Item No. AD-1.4:                    Reference Deleted Sections

Item No. AD-1.11:                    Reference Revised Drawings

RESPONSES AND VARIOUS CLARIFICATIONS TO  
F13-13 INDIAN SPRINGS HIGH SCHOOL ATHLETIC COMPLEX

**INDIAN SPRINGS  
ATHLETIC COMPLEX**

COMMUNICATION SYSTEMS CONDUIT BLOCK DIAGRAM

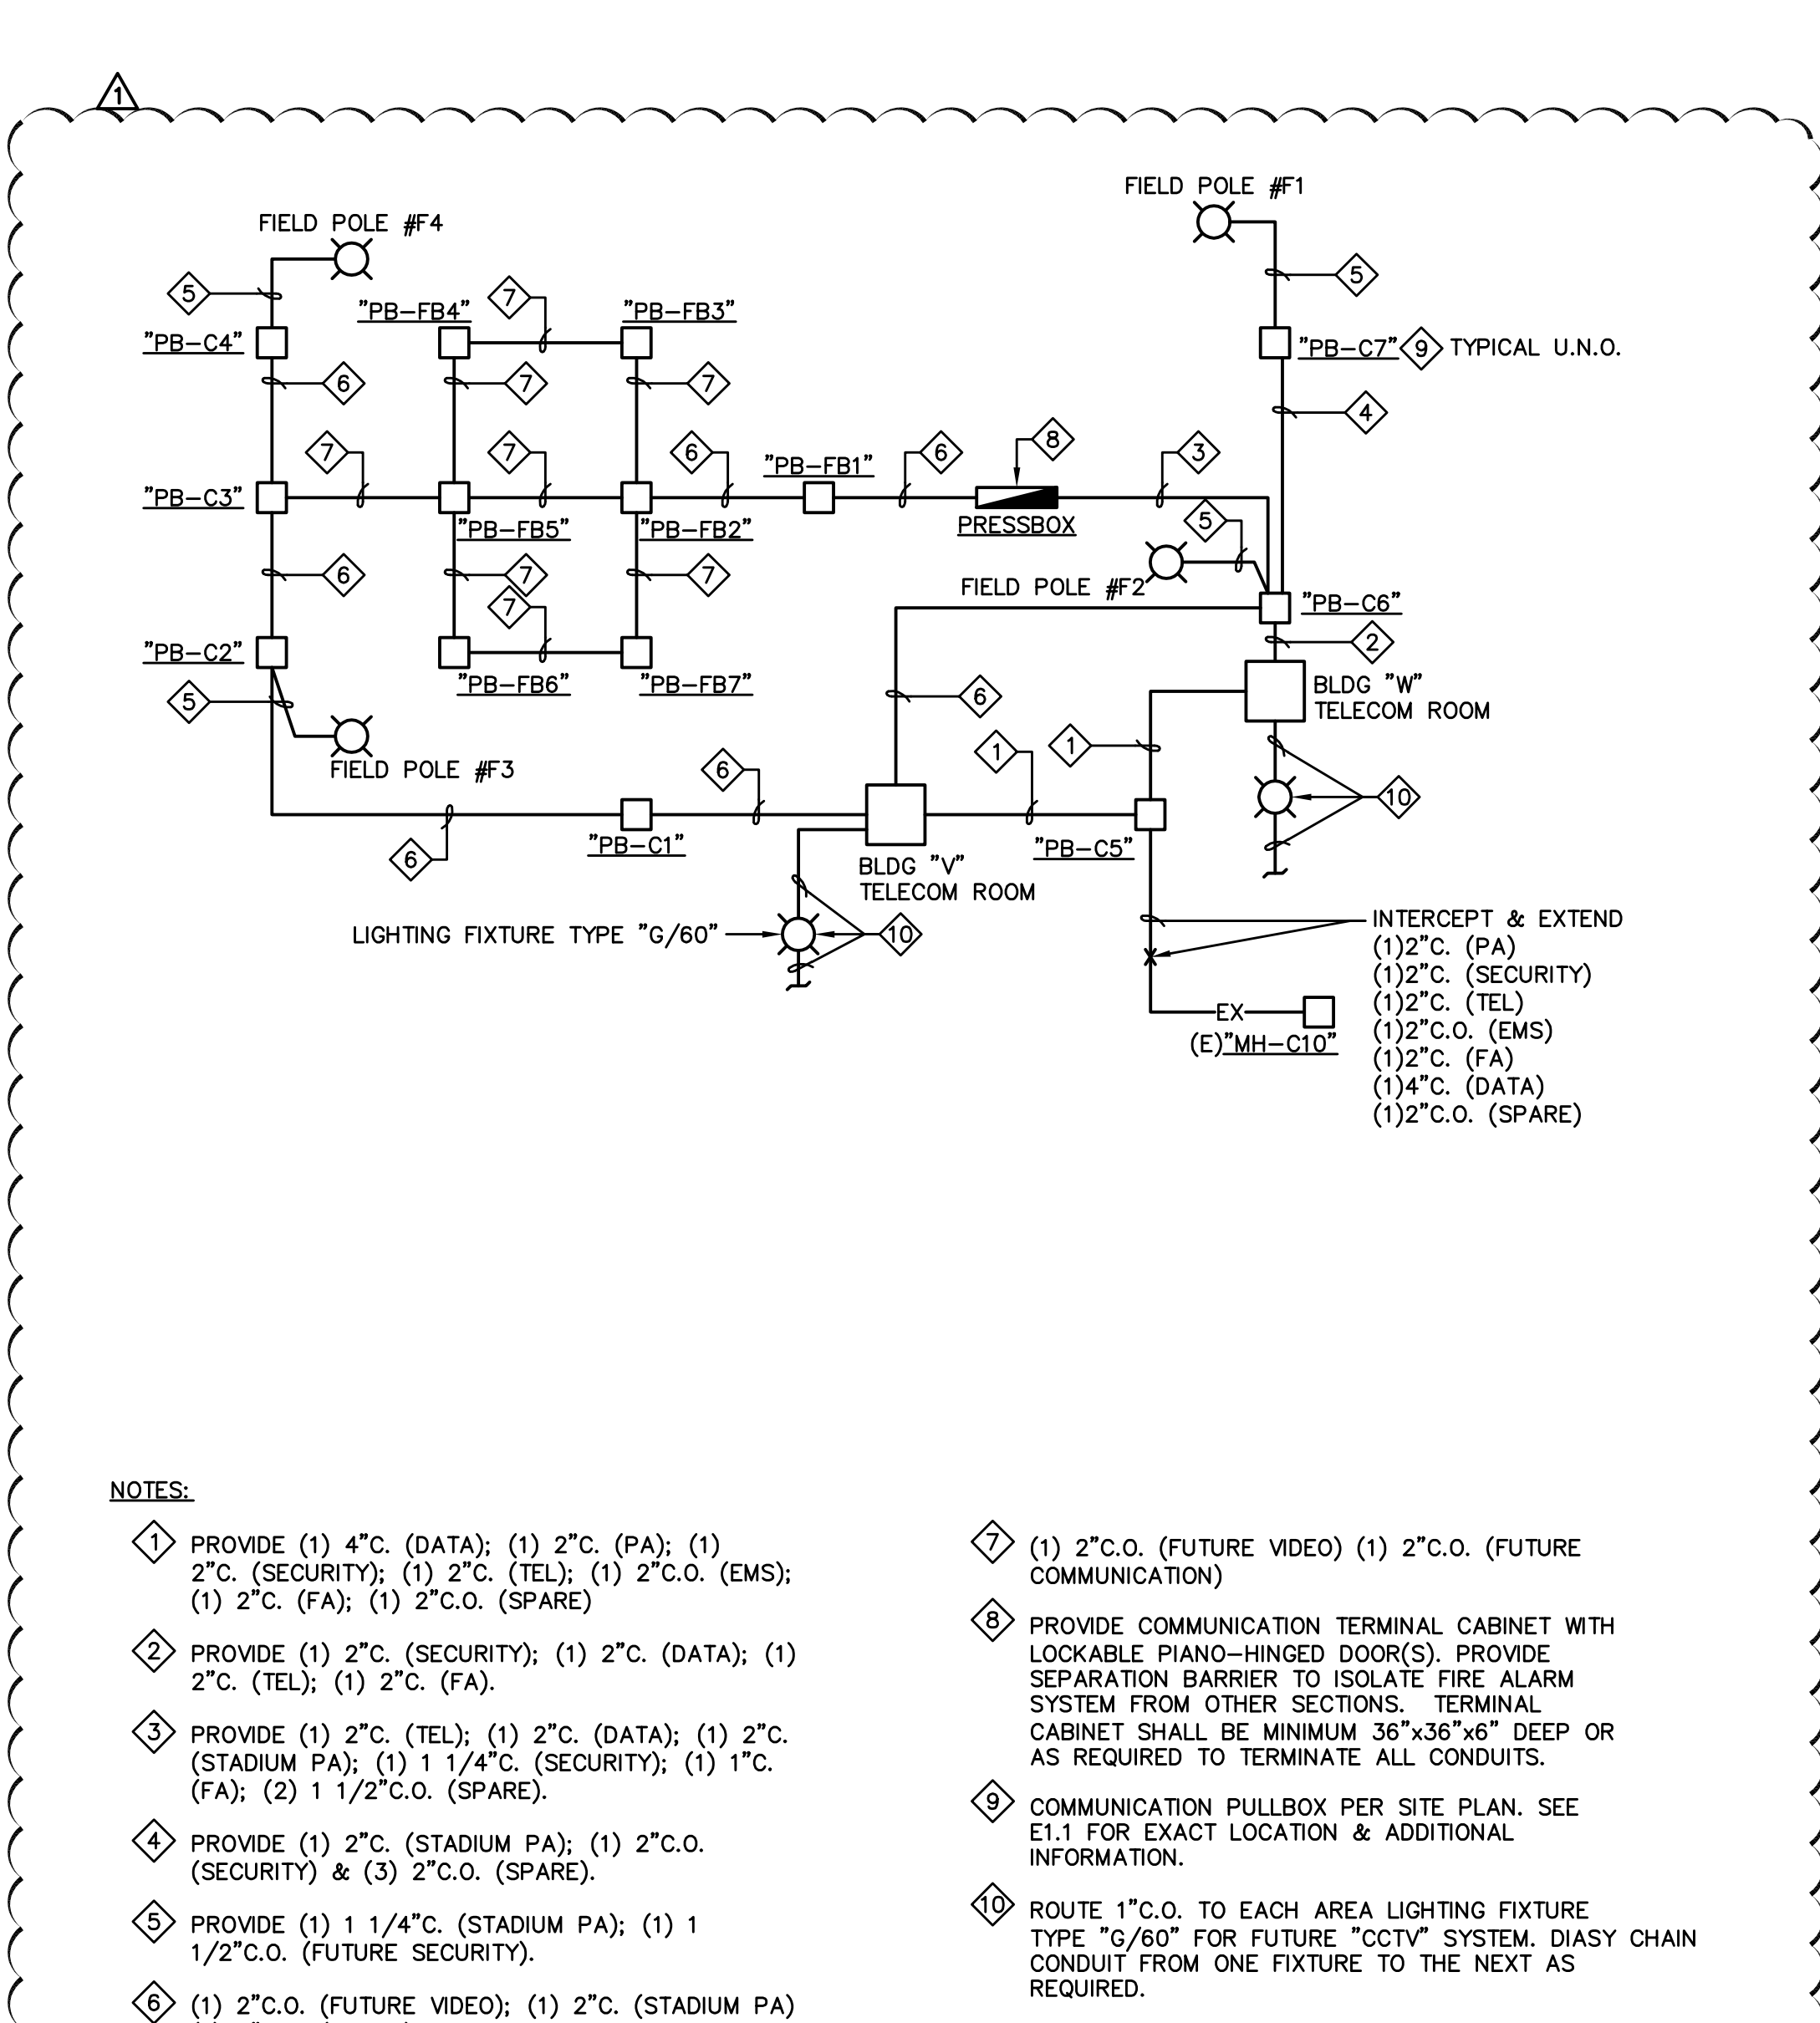
AD-1.01 (Reference A1.30)  
AD-1.02 (Reference E1.1, Electrical Site Plan)  
AD-1.03 (Reference E3.0, Communication Riser Diagrams)

Reference Drawing: K6/A10.20

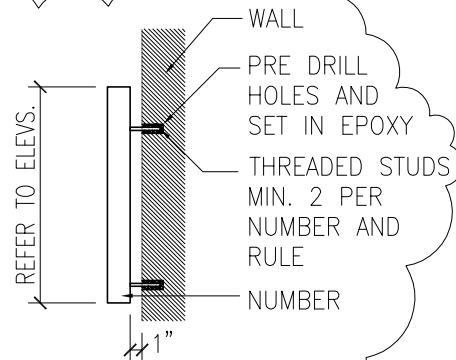
- A. On Keynote 26, change detail reference to read: ".....K6-A10.20",

NOTES:  
 CAST ALUMINUM LETTERS (HEIGHT AS INDICATED ON ELEVATIONS) 1-7/8" DEEP. FINISH TO BE SATIN POLISHED FACE, FILED EDGES, DURANODIC BRONZE ANODIZED. STROKE WIDTH TO BE 2" WIDE. LETTERS TO BE INSTALLED TO WALL SURFACES WITH THREADED STUDS SET IN ADHESIVE-FILLED HOLES.

1. CONTRACTOR TO PROVIDE SHOP DRAWINGS.
2. PROVIDE TEXT AS INDICATED IN DRAWINGS

Reference Drawing: K15\A10.20

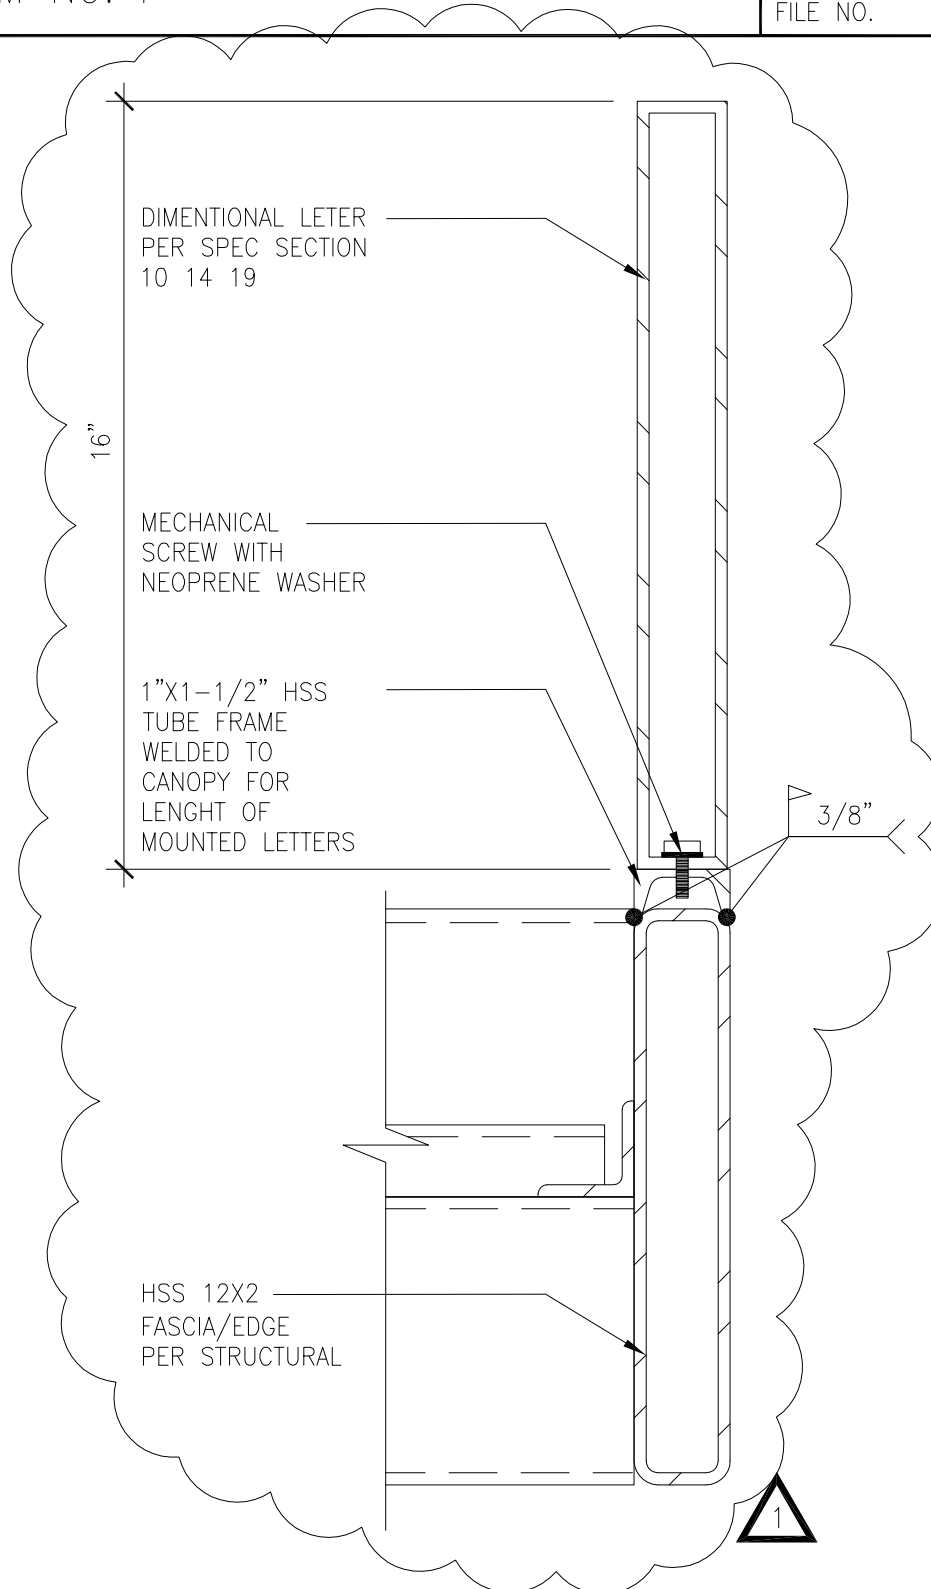
AD-1.04 (Reference K6/A10.20, Building Details)  
AD-1.05 (Reference K15/A10.20, Building Details)
